**project.** Sherwood Library Renovation | 1225 Wonderland Rd N, London, ON

**project no.** 23-006

This Addendum is issued before the award of Contract to inform the Contractor of certain modifications to the work described in the Drawings and Specifications dated September 18, 2024.

end of addendum | 001

A230 Scale: 1 1/2" = 1'-0"

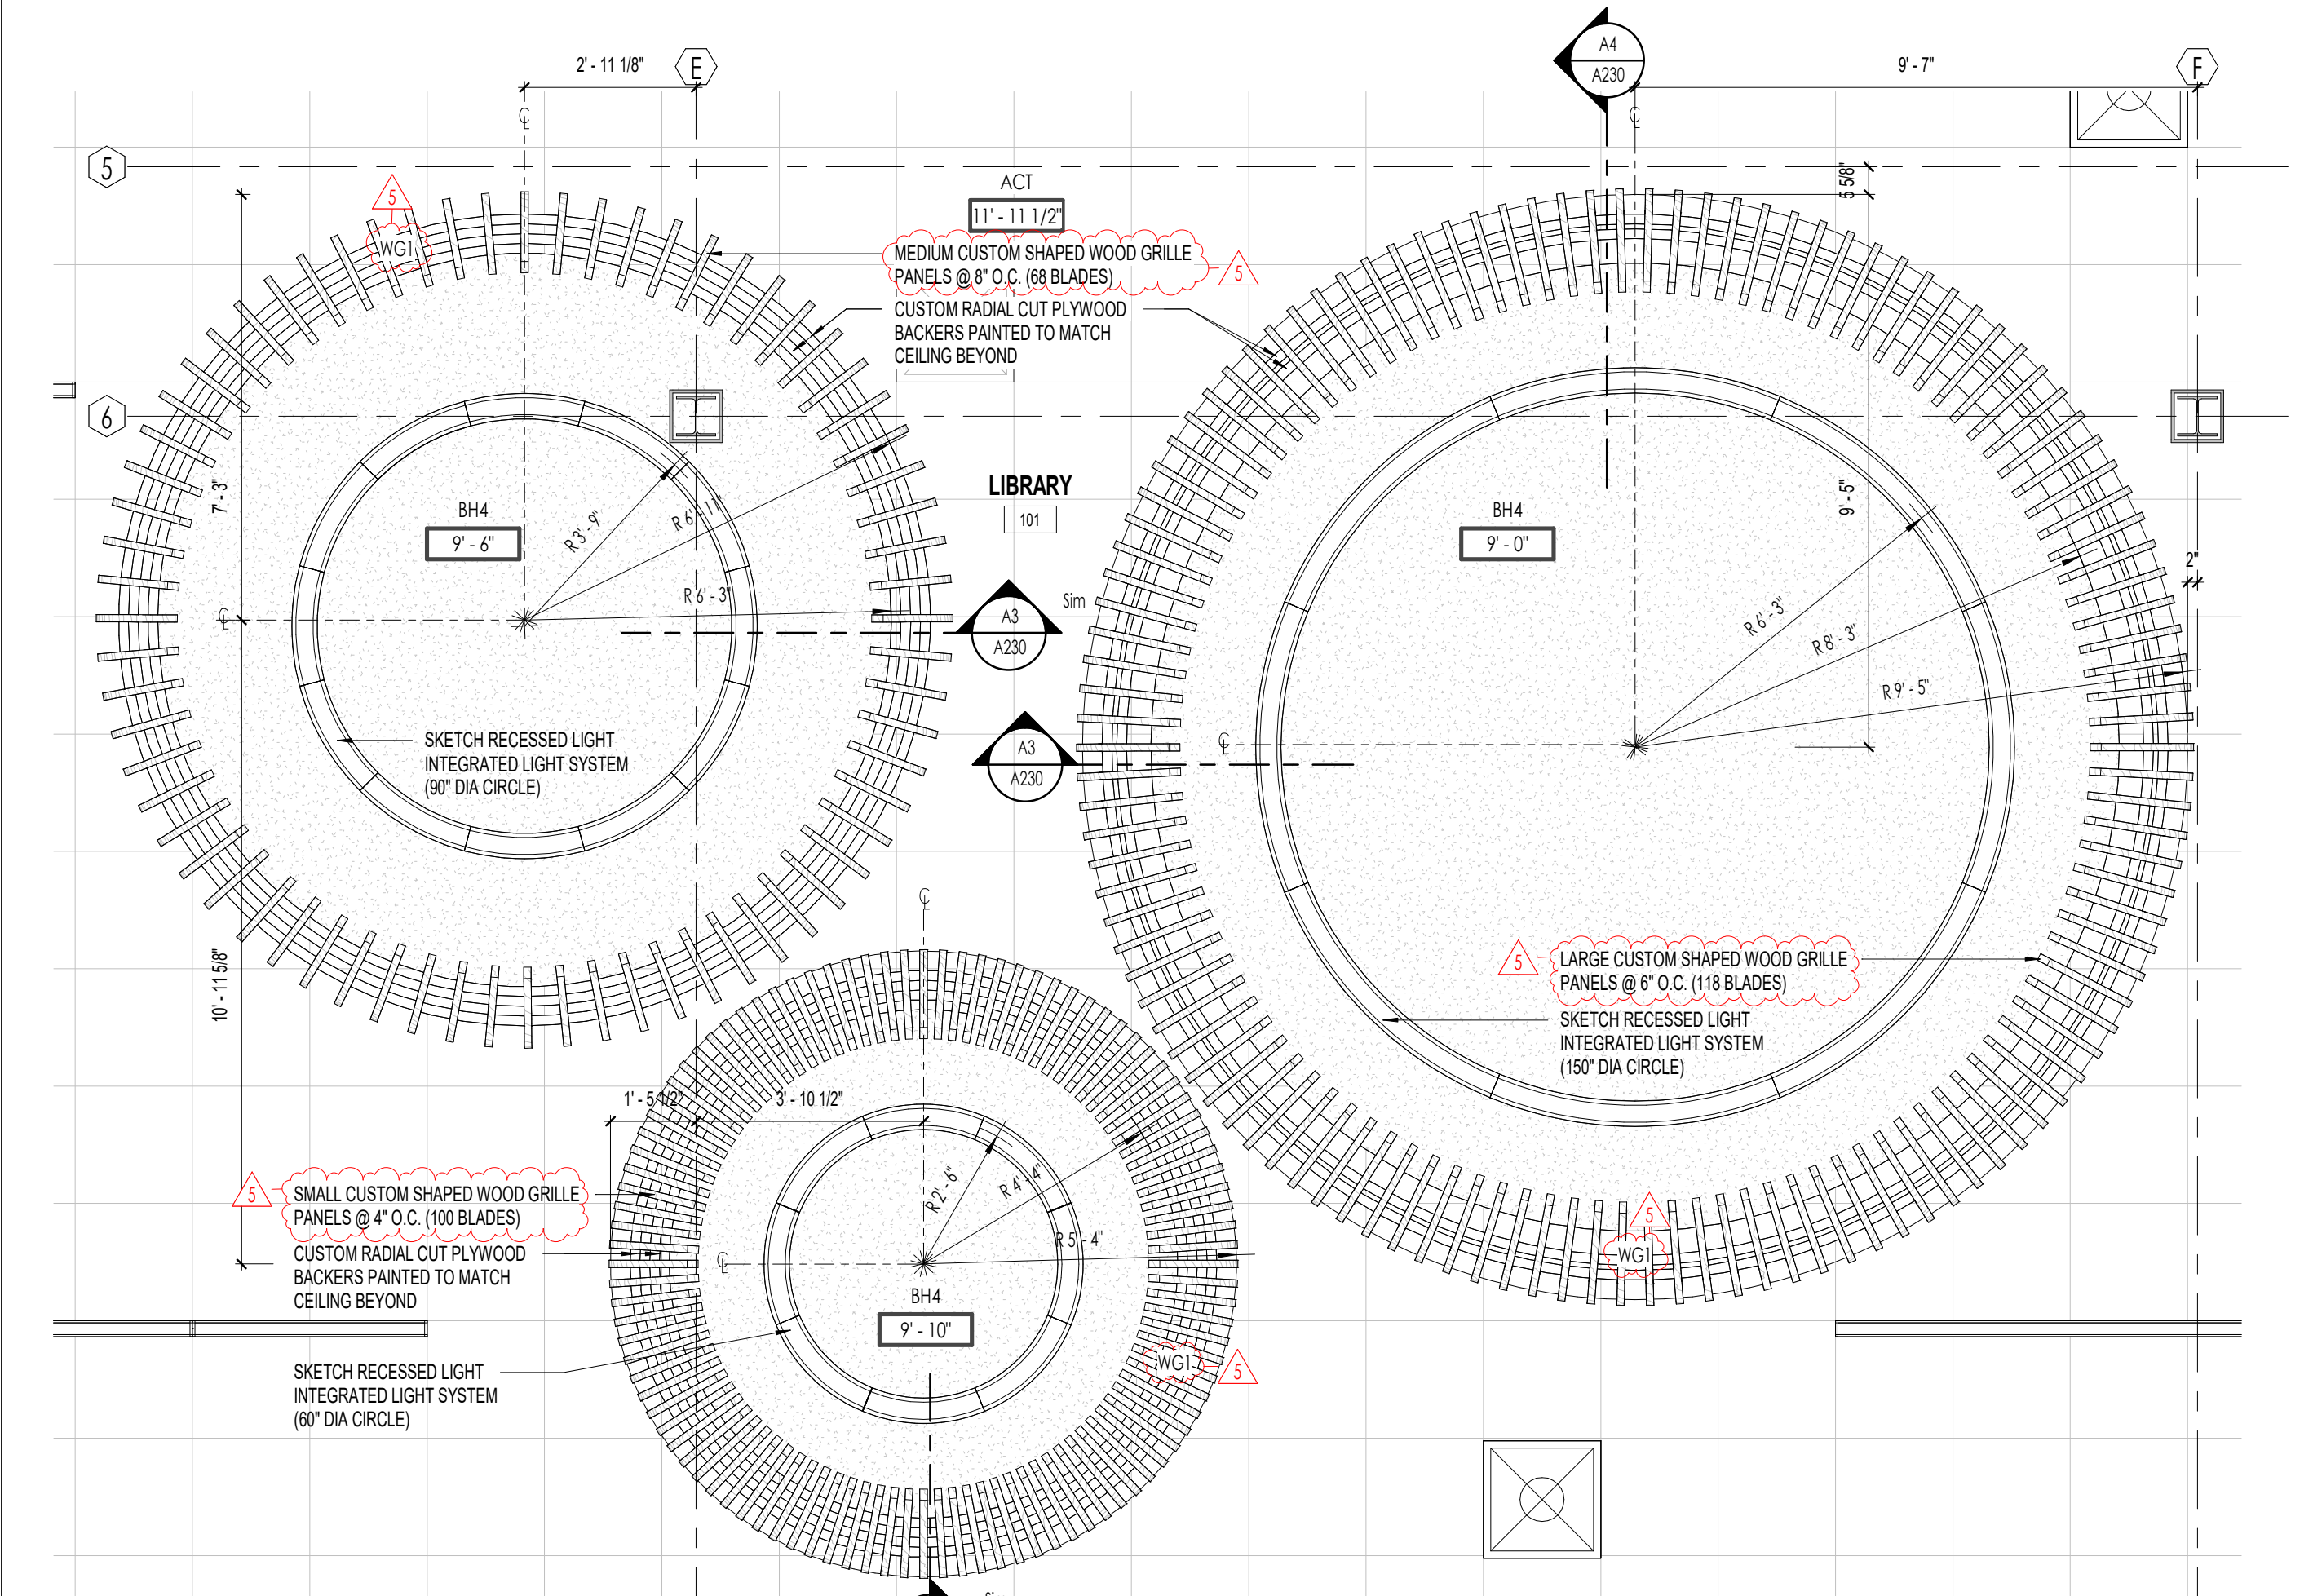
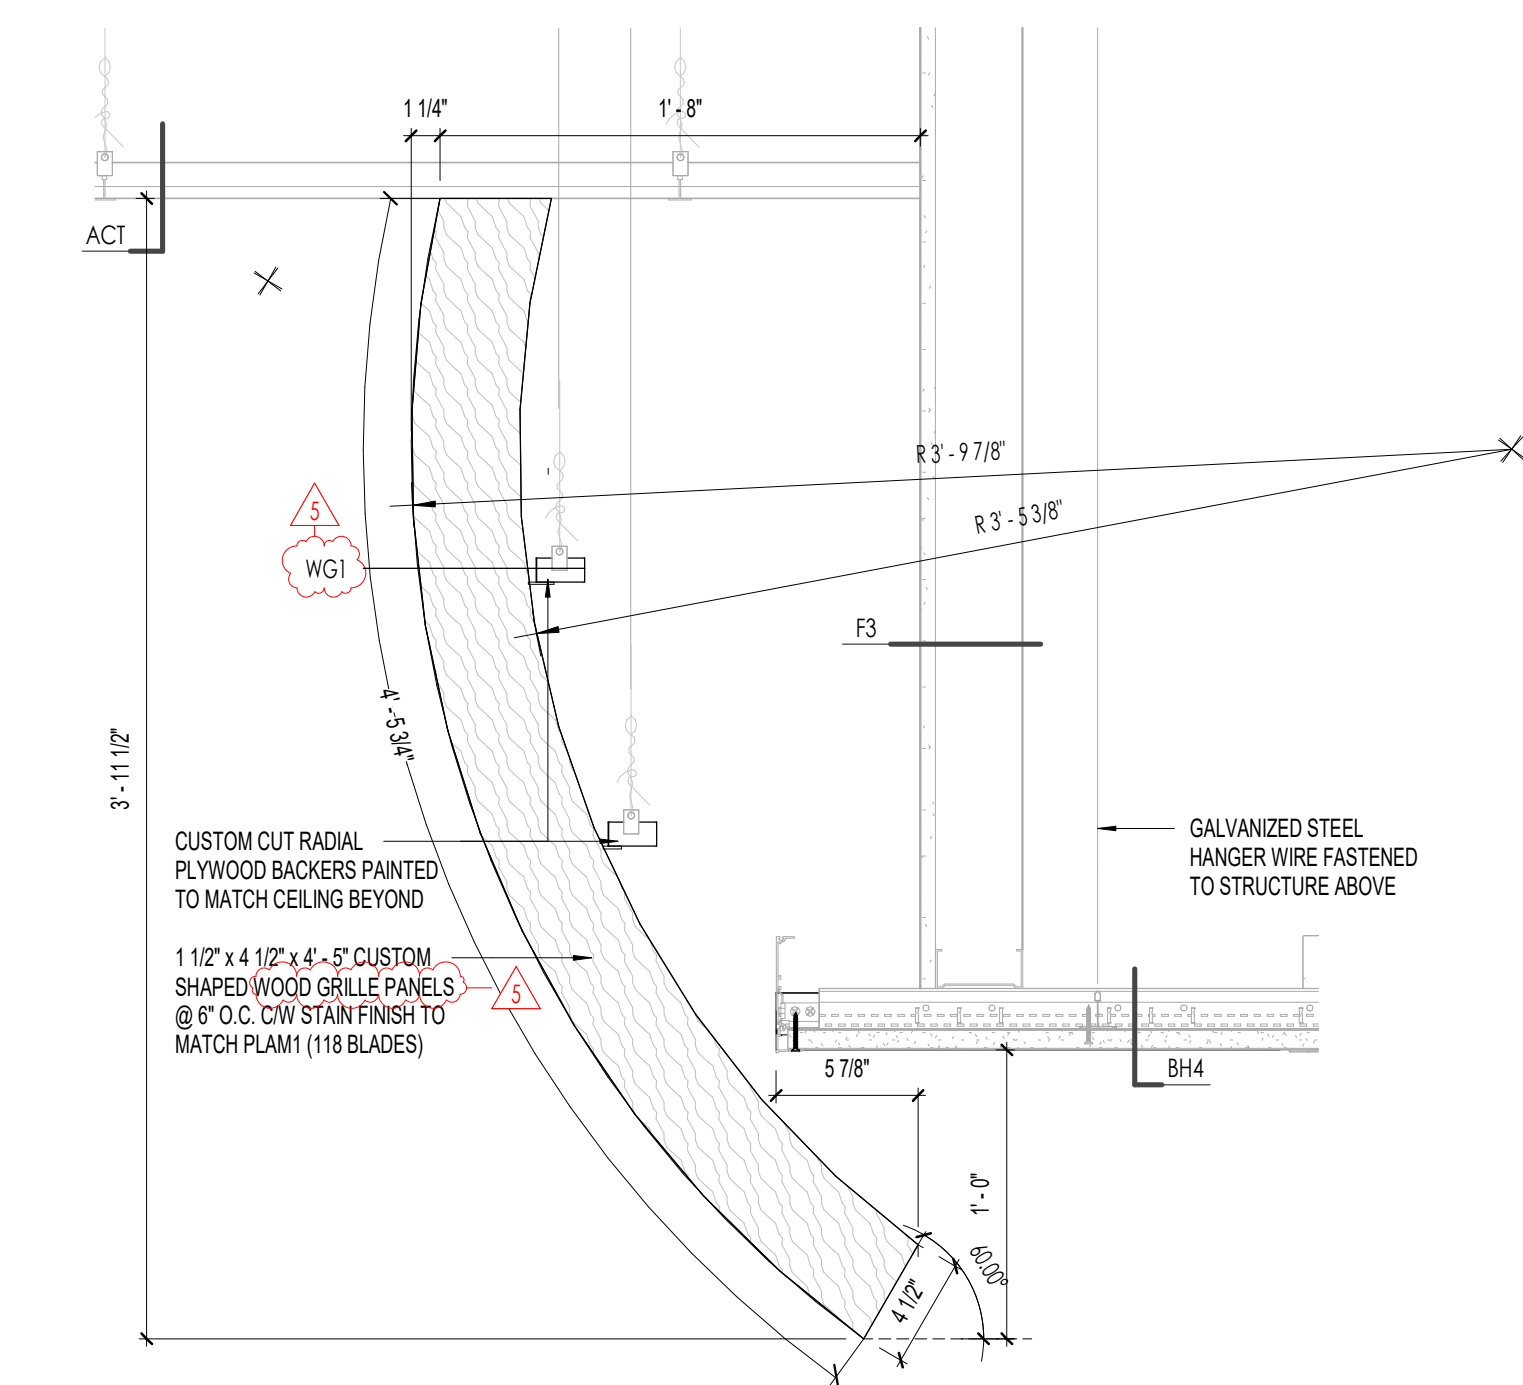
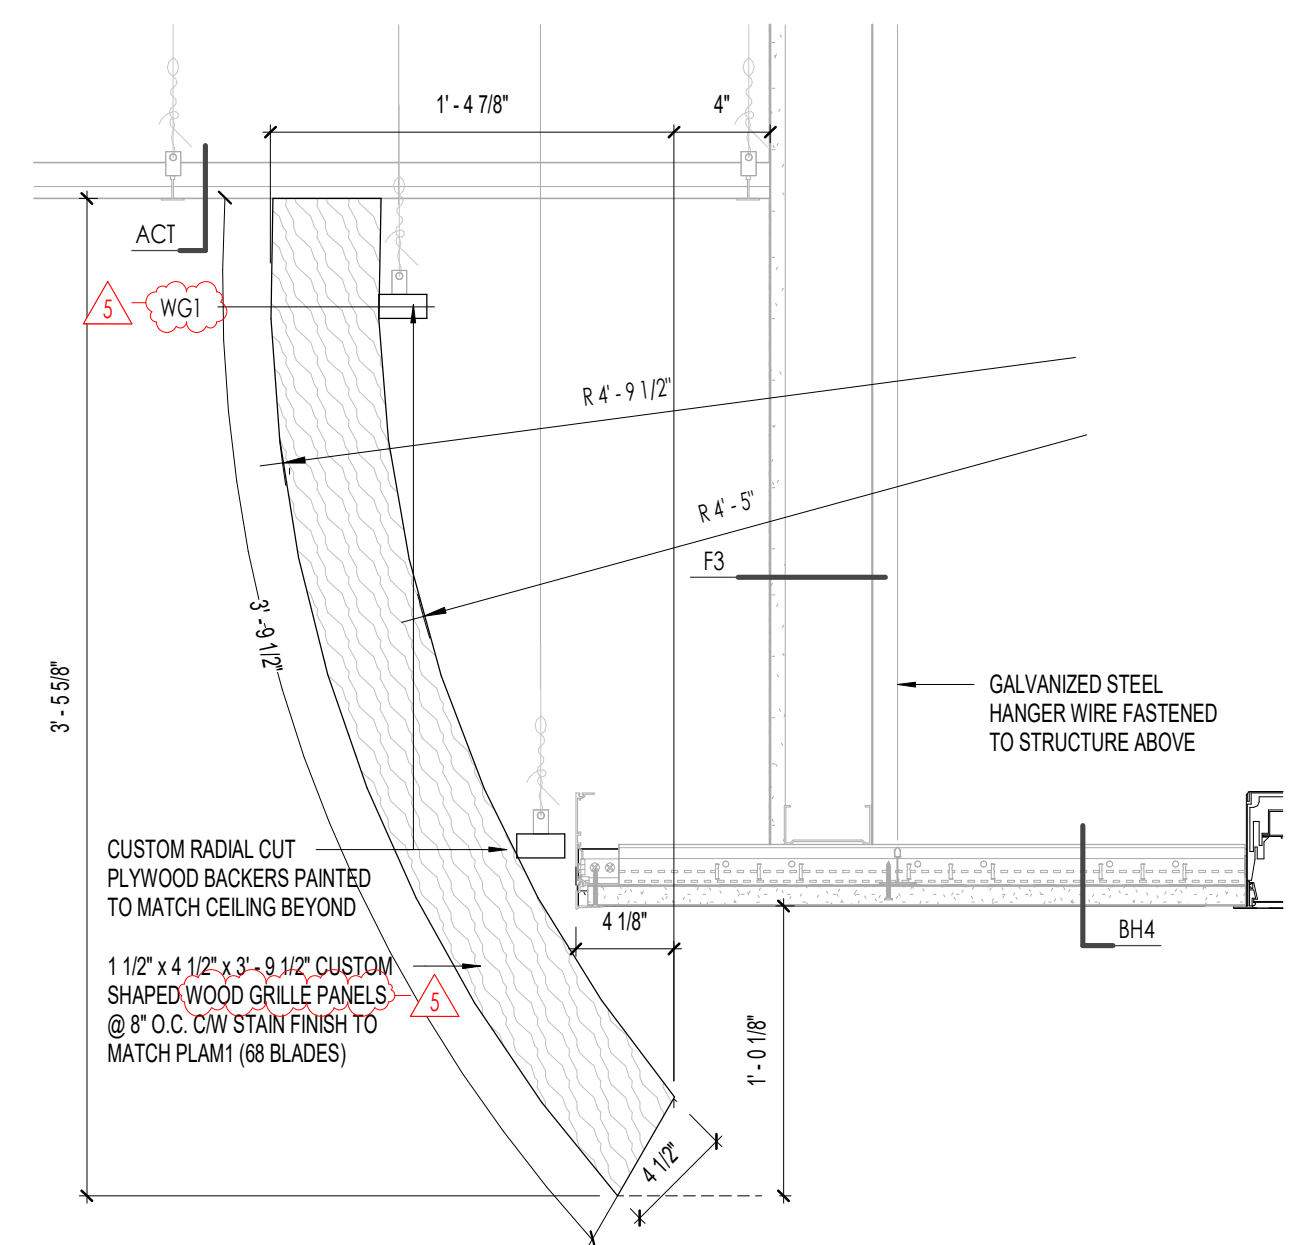
item no.	REFER TO DESCRIPTION
1	<b>Contractor/Sub-Trade Questions (Received by 2024.10.02)</b>
<b>CEILING QUESTIONS:</b>	
1.1	<p><b>Question:</b> A230 Ceiling Design- Will there be a product spec or preferred vendor for purchase?</p> <p><b>RESPONSE:</b> The ceilings on architectural sheet A230 are an Armstrong product composed of AcoustiBuilt suspended ceiling systems (BH4) and Wood Grille Backer ceiling system (WG1). Please see attached Specifications for these ceiling systems. Updated sheet A320 has been included for clarification on the verbiage pertaining to these systems.</p>

<b>3</b>	<b>Architectural Drawings (Addendum 001) dated 2024.10.02 (4 pages)   have regard to revisions and/or clarification to the following drawings</b>
3.1	<p>A-230 CEILING DETAILS</p> <p>Refer to attached revised A320.</p> <p><b>Revise verbiage for WG1 system, including wood grille panels.</b></p>
3.2	<p>ICC-200 MILLWORK KEY PLAN - NORTH</p> <p>Refer to attached revised ICC-200.</p> <p><b>Revise MILLWORK FINISH LEGEND and remove:</b></p> <ul style="list-style-type: none"> <li>• <b>Plam 3, Plam 4, Plam 5</b></li> <li>• <b>UP1, UP2, UP3, UP4, UP5, UP6</b></li> </ul>
3.3	ICC-200 MILLWORK KEY PLAN - SOUTH
